25 November 2015

RE: SSD 15_7033 – Site 53 | 2 Figtree Drive, Sydney Olympic Park

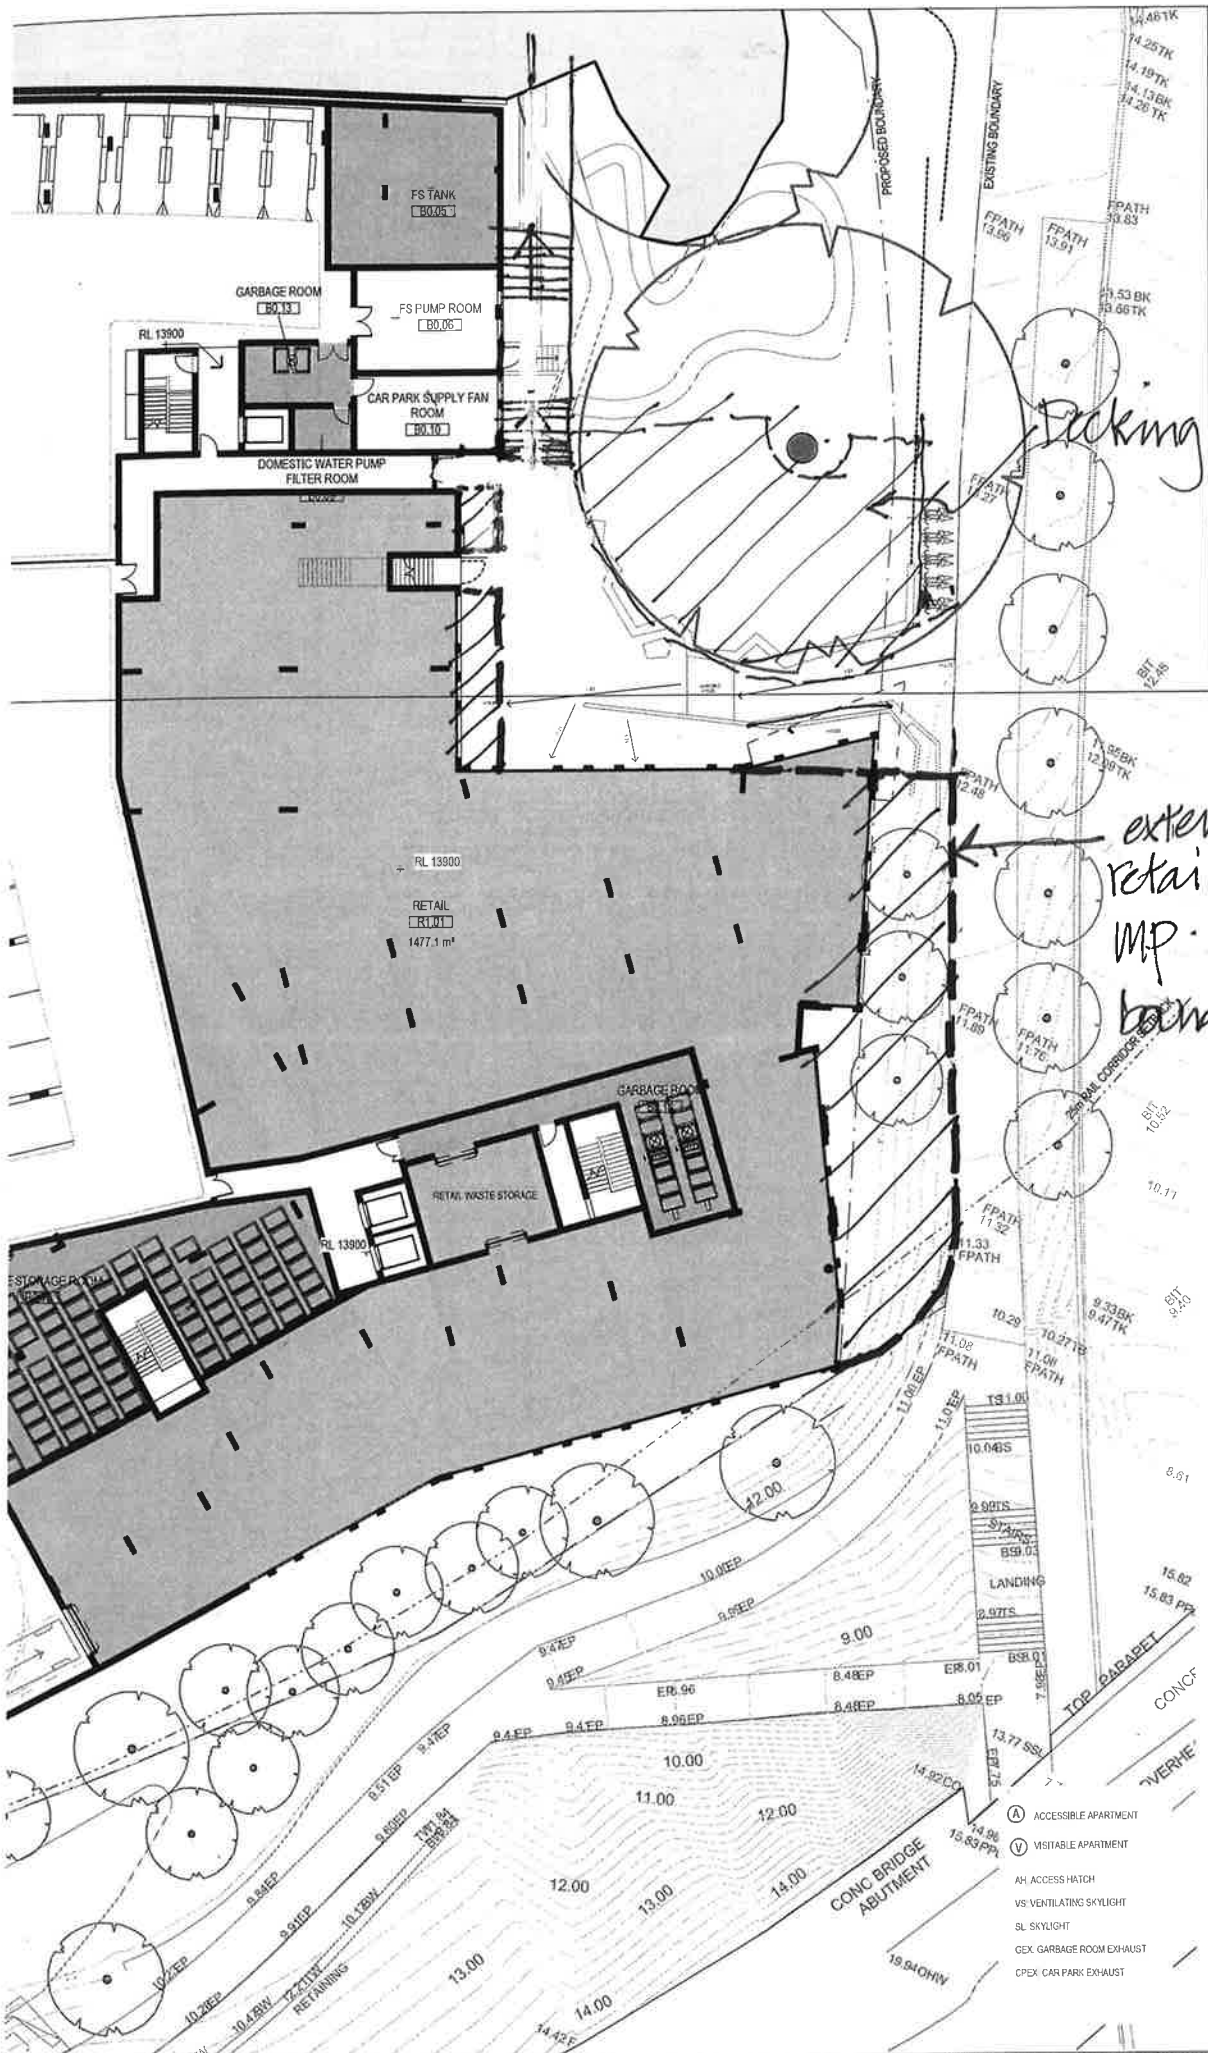
The building footprint does not extend to the master plan boundary on Australia Avenue, resulting in a heavily landscaped setback that gives a very suburban feel to this major frontage at the entry to the town centre. It is recommended that the ground level retail area be extended to the street boundary as shown in attached marked up sketches (SK01 and SK02). The use of brickwork for this frontage is supported.
